Amendments to the Drawings:

LIQUID CRYSTAL DISPLAY ELEMENT
US Serial No. 10/013,978 - Inventors Kenneth M. Fallon et al.

Fig. 2

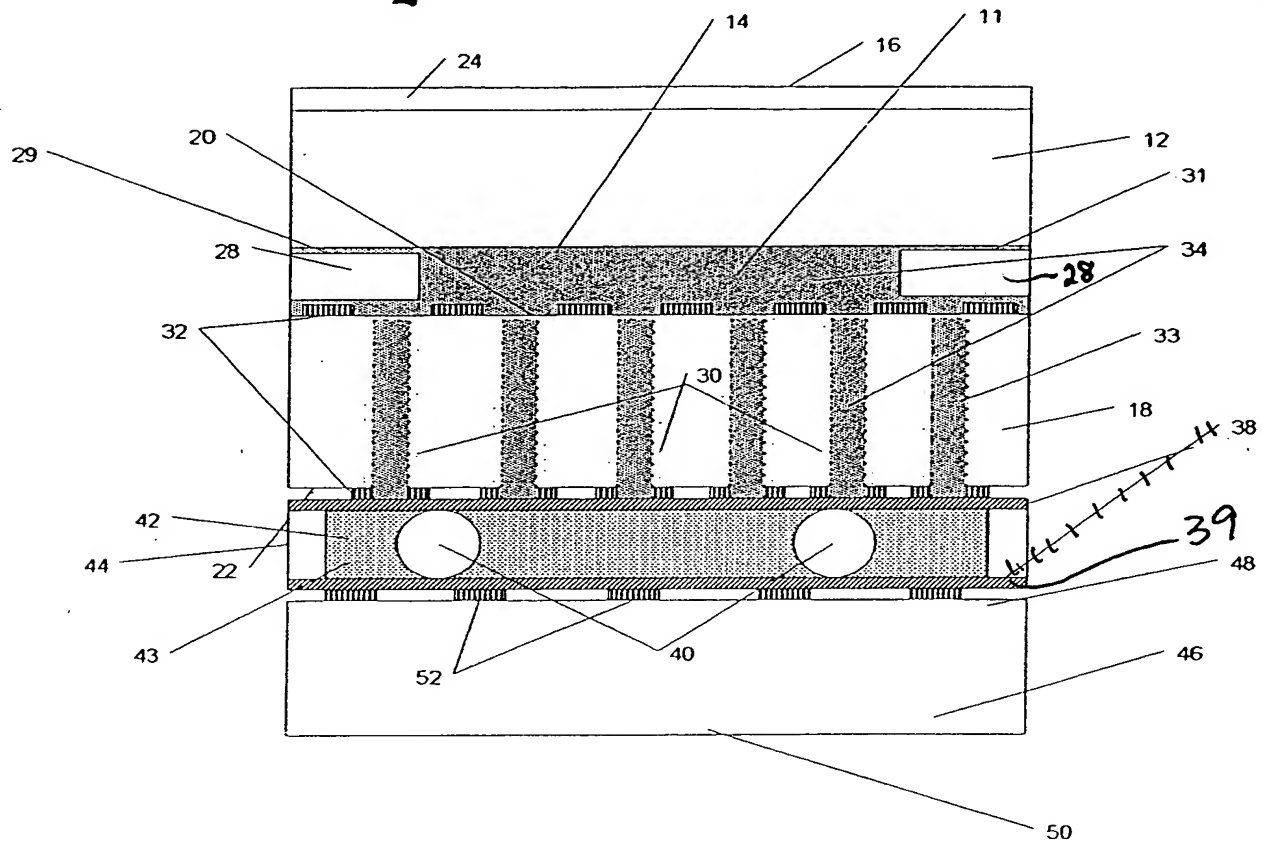
A marked-up copy showing changes in red to Figs. 2 and 6 of the drawings are enclosed at the end of Applicant's response. Also enclosed is a set (6 sheets) of formal drawings depicting Figures 1-7, incorporating the changes to Figs. 2 and 6. Approval by the Examiner is respectfully requested
